Service Bulletin

Title: **RMX 2450 AC Wire Replacement**
Bulletin #: RMX0005 Issue Date: December 13, 2000
Models Affected: RMX 2450 Bulletin Revision: A
Production Range: 01/2000–10/2000 (serial # 0100xxxxx–1000xxxxx)

Figure 1. The insulation is pinched through to the conductor. The wire must be replaced.

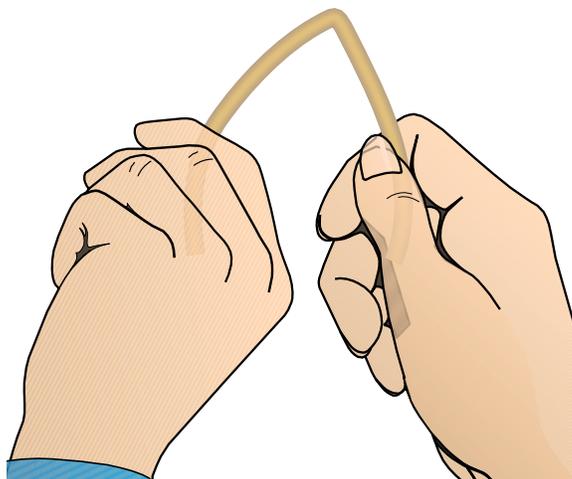
Examine the wires where they were tied to the bridge lance. Flex the wires to expose any possible deep cuts in the insulation or hidden wire breaks. See Figures 1 and 2.

Either of these conditions mandates the replacement of a damaged wire:

- A break in the insulation exposes any of the wire's strands.
- Any wire strands appear to be broken, whether visible or not.

1. If the AC wire from the circuit breaker to the switch is to be replaced, then cut the heat shrink tubing away from where the wire connects to the circuit breaker.
2. Cut the wire off and remove its remnants and the excess solder from the circuit breaker terminal.
3. Slip the heat shrink tubing over the wire and slide it out of the way.
4. Fashion the stripped and tinned end of the new 25" wire into a hook and attach it to the circuit breaker terminal. Using long-nose pliers, tighten the hook so it holds onto the terminal securely.
5. Solder the wire to the circuit breaker terminal.
6. Slide the heat shrink tubing over the solder joint so it fully covers the joint and the terminal. Shrink the tubing fully using the heat gun or by holding the tip of the soldering iron close to the tubing.

1. If the AC wire from the switch to the AC board is to be replaced, then remove the AC board from the chassis.
2. Cut away any silicone or hot glue from where the wire joins the AC board. Unsolder and remove the wire. Clear the hole of excess solder.
3. Insert the stripped and tinned end of the new 19" wire into the hole on the AC board and solder it in place.
4. Reattach the AC board to the chassis.
